Re: Interpretation for RZ/FDP 2003-PR-026, Elm Street Development, Inc. and JCE Inc. (Wedderburn), Tax Map Parcel 39-2 ((1)) 15-18, 18A, 18B, 18C, 18E, 32, 33A, 33B, 33C and 39-3 ((38)) A: Stream Restoration

**RE: Cedar Lane/Wedderburn Station Drive
Stream Restoration
RZ Case #2003-PR-028
County Plan #7929-SD-002**

**RE: Wedderburn Estates Stream Restoration Plan
Interpretation for RZ/FDP 2003-PR-026**

Reference: Cedar Lane Wedderburn Station Drive
7929-SD-002-4

PROJECT: WEDDERBURN PROPERTY
 PROPOSED GRADING PLAN
 AND PROFILE
 FAIRFAX COUNTY, VIRGINIA

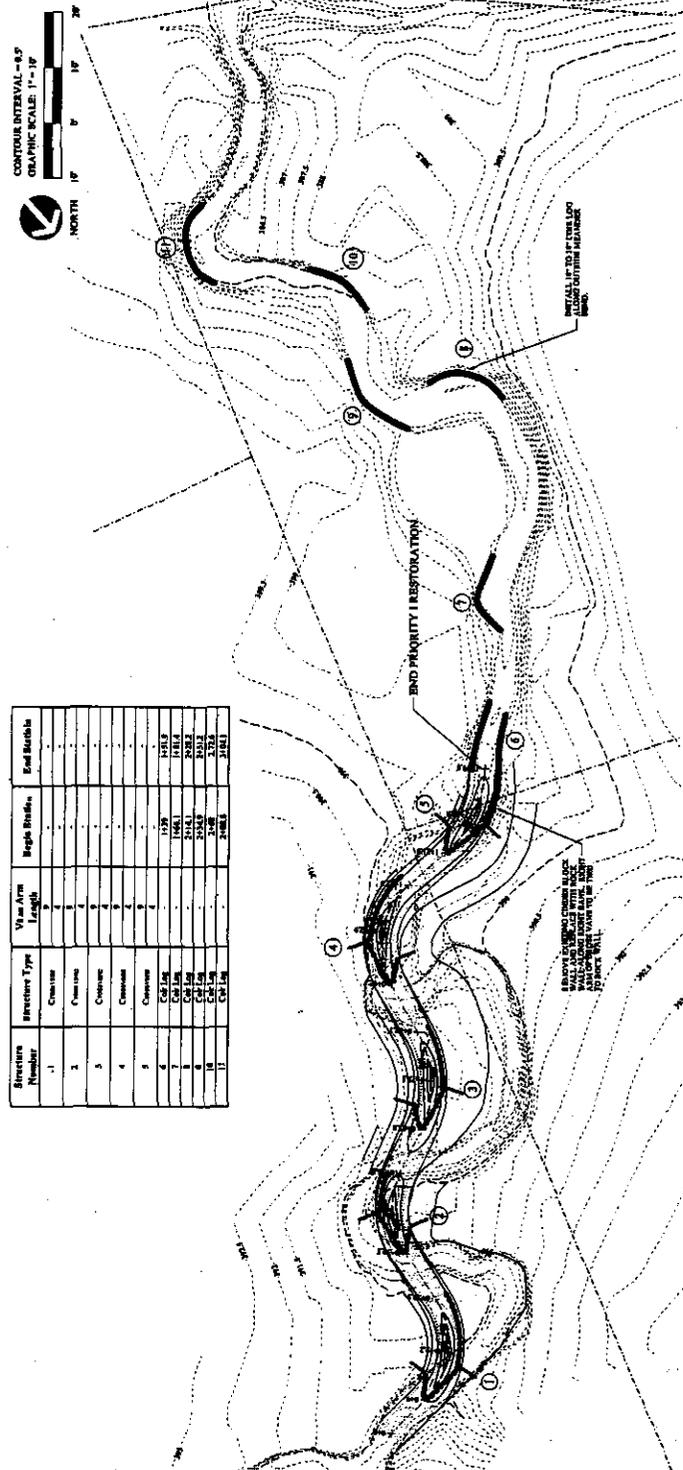
The most recently submitted proposed Grading Plan and Profile shows the details of the stream restoration project, which will consist of approximately 139.6 linear feet of major restoration on-site and on adjacent Lot 6 and 149 feet of coir log placement off-site on adjacent Lot 5. You have stated that all of the work will be conducted within the 100 foot wide stream buffer easement that was required to be recorded prior to the issuance of the first Residential Use Permit (RUP), pursuant to Proffers 15 and 16. Both proffers specifically allow for the downstream improvements required by Proffer 33 to take place within the easement. The plan shows an area of priority restoration on-site and in the southernmost corner of Lot 6. Details of the priority restoration are contained in the Proposed Grading Plan and Profile and generally consist of grading and stabilizing the banks and making improvements in the channel using stakes, fill, and erosion control matting. Roughly at the boundary with Lot 5 the priority restoration is terminated and converts to the placement of coir logs along the stream banks. As I understand it, the use of coir logs placed by hand with no grading will stabilize the banks and prevent further erosion and tree loss and will not require the removal of existing trees.

The concept of stream restoration that is proposed by Angler Environmental, dated January 19, 2012, for the Wedderburn Property, would be considered satisfactory, if a revision to the referenced plan is submitted that provides the following:

- The designer of the stream restoration plan must certify that the natural channel design is based on established guidelines and cite what guidelines are being used in the design. These natural channel design concepts must be based on engineering analysis and fluvial geomorphic processes.

- The plan revision must include a plan and profile showing both existing and proposed grades using 6" contour interval topography. Design calculations (based on the referenced established guidelines) must also be included to ensure the stability of the natural channel practices. These calculations should include, at a minimum, a narrative describing the hydrologic basis of the design and relevant computations (e.g. shear stress or other scientifically valid methods) demonstrating that the stream bed will remain viable and functioning in accordance with the established natural channel design concepts used for the project.

- Stability of the floodplain must also be demonstrated through a comparison of modeled, overbank velocities during the 100-year storm with published allowable velocities (based on soil type and vegetative cover type). Soil types used for the determination of allowable velocities can be determined from field samples or county soil maps. Plan and profile of the modeled 100-year water surface elevation must also be provided.

Based on the above, it is my determination that the proposed stream restoration discussed herein and described in your submission is in substantial conformance with the proffers and the CDP/FDP, provided that no additional clearing and grading beyond that depicted on the Erosion and Sediment Control exhibit that was stamped received by ZED, DPZ on July 5, 2012, occurs; that a revised tree preservation plan is submitted and approved prior to any land disturbing activities on the site for this project; that understory vegetation and soil in tree preservation areas are protected; that limits of clearing and grading are flagged prior to land disturbance; that a re-planting plan is developed and implemented for disturbance to vegetation resulting from this project; and, that tree protection fencing is installed around trees shown to be preserved, subject to approval by DPWES and UFM.

RIEFLER CROSS SECTION

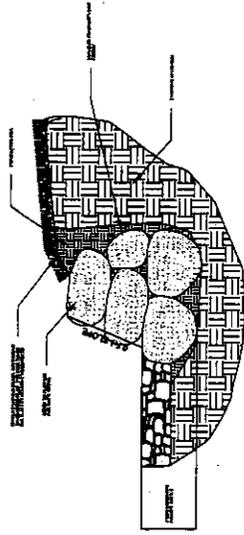
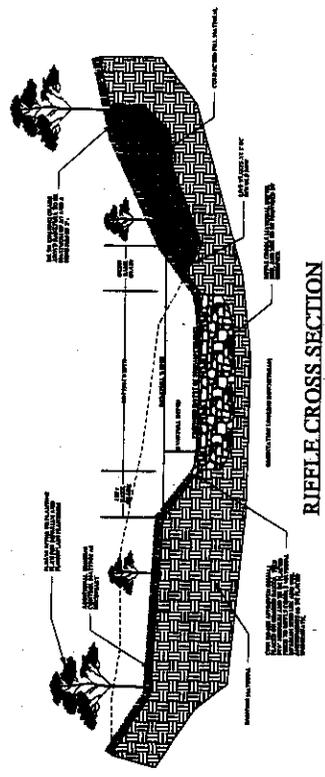
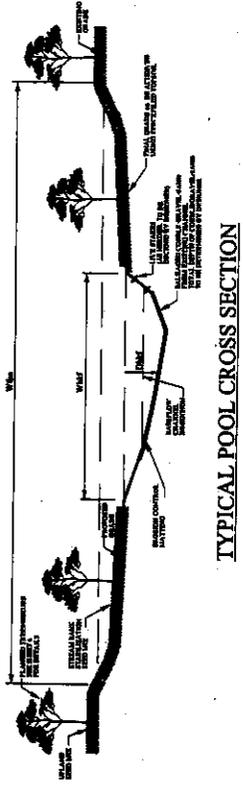
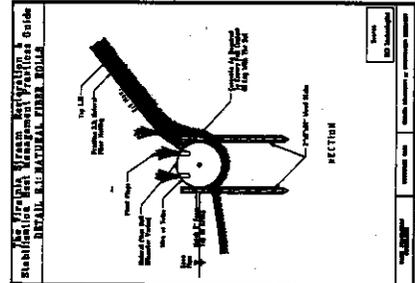
- Typical details for various cross-section types (i.e. riffles, pools, etc.) must also be provided. These details are to provide enough information for the construction of the improvements as well as show the level of the water surface elevations resulting from the 2-year and 10-year design storms, as well as the bankfull condition.

EROSION AND SEDIMENT CONTROL

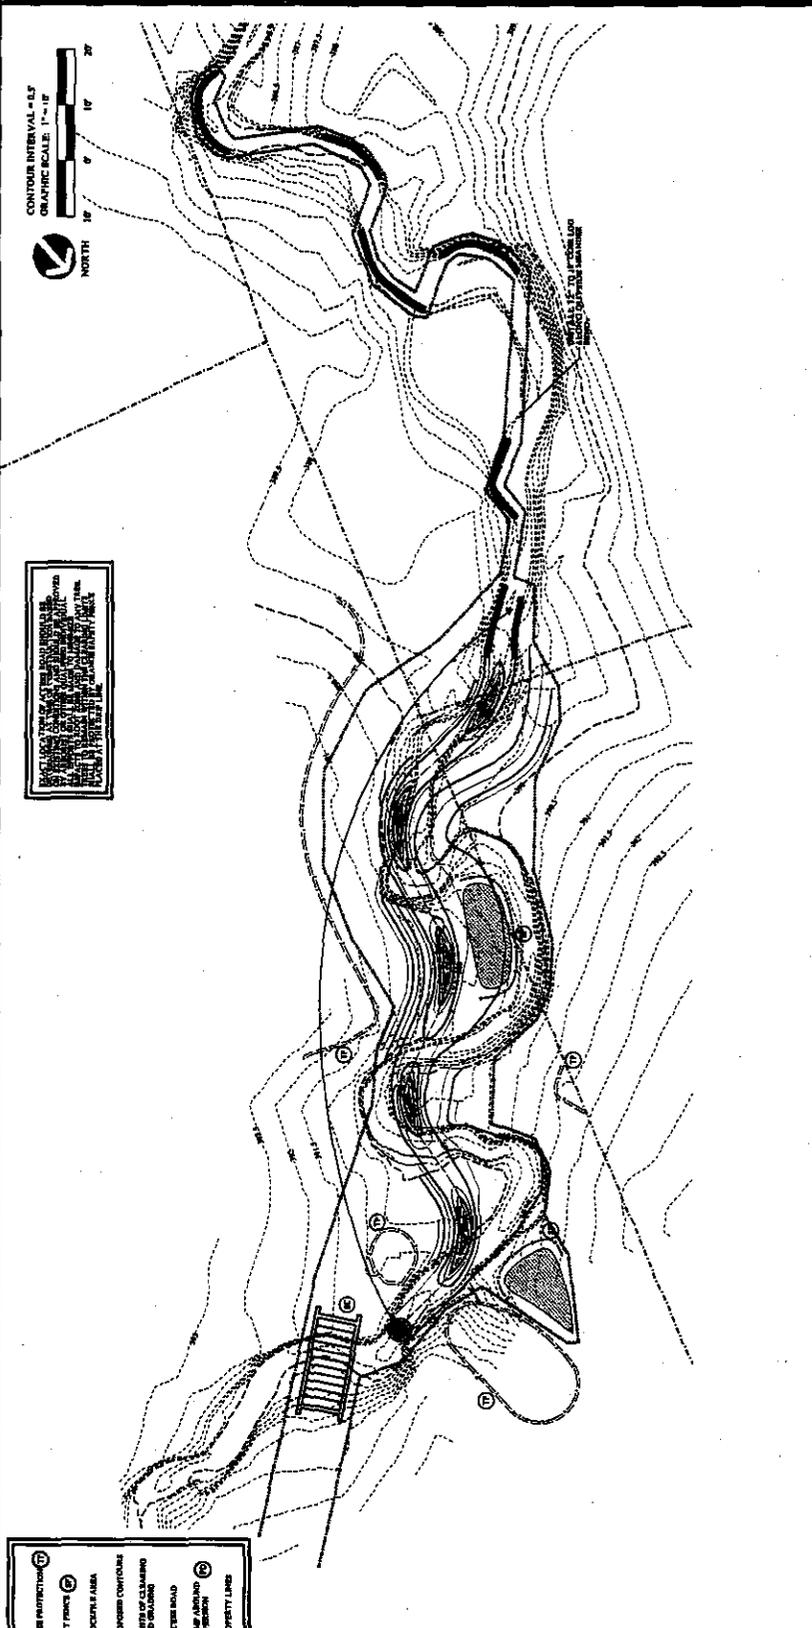
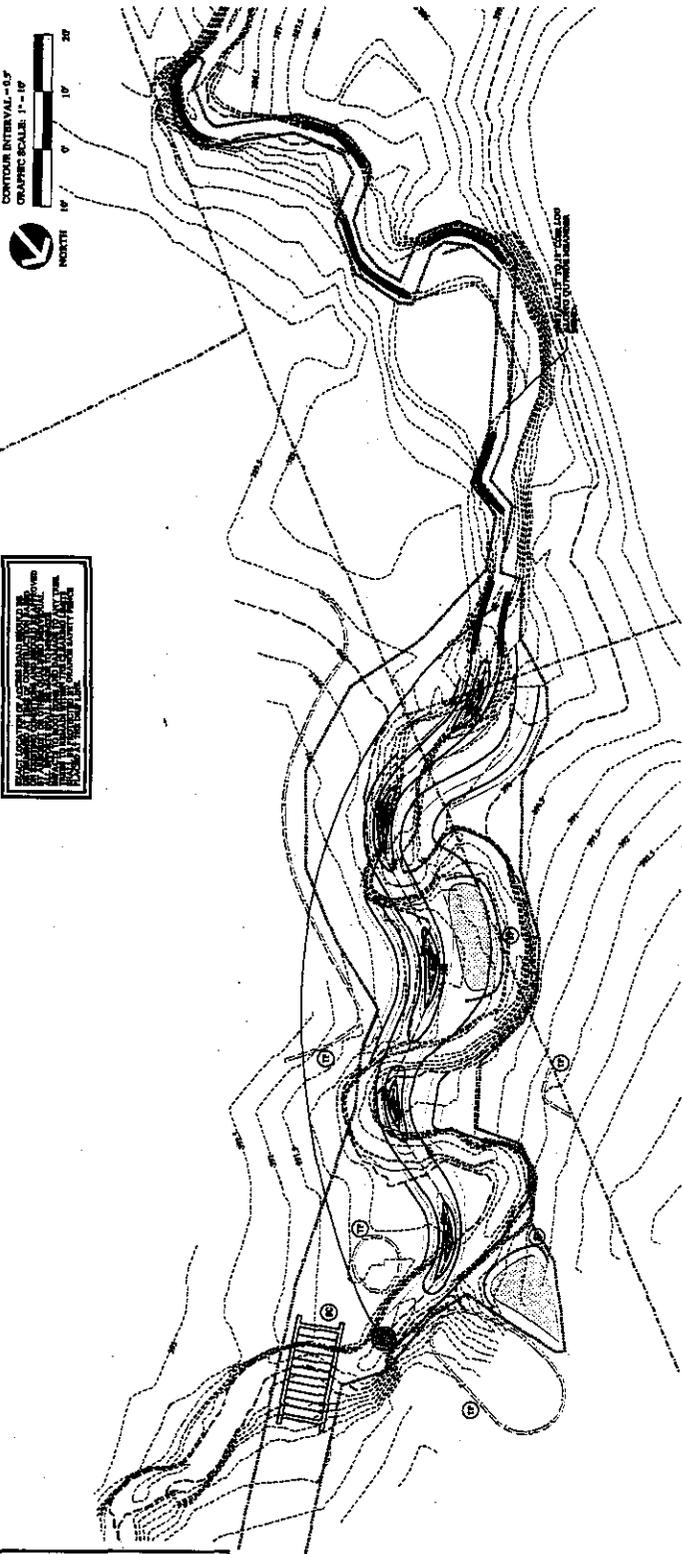
Performance of the priority stream restoration project will necessitate clearing and grading beyond the approved limits of clearing and grading shown on the CDP/FDP. In addition, access to the restoration area will require minor clearing and grading beyond the limits of clearing and grading. Access to the work area is shown on your submitted red-line drawing west of the SWM/BMP facility outside the limits of clearing and grading. Your exhibit shows that an area to the north of this within the limits of clearing that was previously intended for this access will not be utilized because you have stated that there are now more existing trees in this area than in the area to the south proposed for access. You have labeled the northernmost area as not disturbed. Proffer 23 states in part that *"The Applicant shall conform strictly to the limits of clearing and grading as shown on the CDP/FDP, subject to allowances specified in these proffered conditions for the installation of utilities and/or trails as determined necessary by the Director of DPWES, as described herein. If it is determined necessary to install utilities and/or trails in areas protected by limits of clearing and grading as shown on the CDP/FDP, they shall be located in the least disruptive manner necessary as determined by UFM, DPWES...."*

- Limits of disturbance (including construction access and material stockpile areas), drainage divides and 6" contour interval topography (including adjacent areas) shall be shown on the plan. A 2-foot contour interval may be used for construction access routes. If there are downstream impoundments, the requirements of Letter to Industry 03-05 must be met.

- The plan revision must include more detailed and appropriate erosion and sediment control measures to protect downstream properties in accordance with the Fairfax County Public Facilities Manual and the Virginia Erosion and Sediment Control Handbook. The plan revision must address the staging of construction and be specific to the project in order to minimize any impacts downstream of the project.
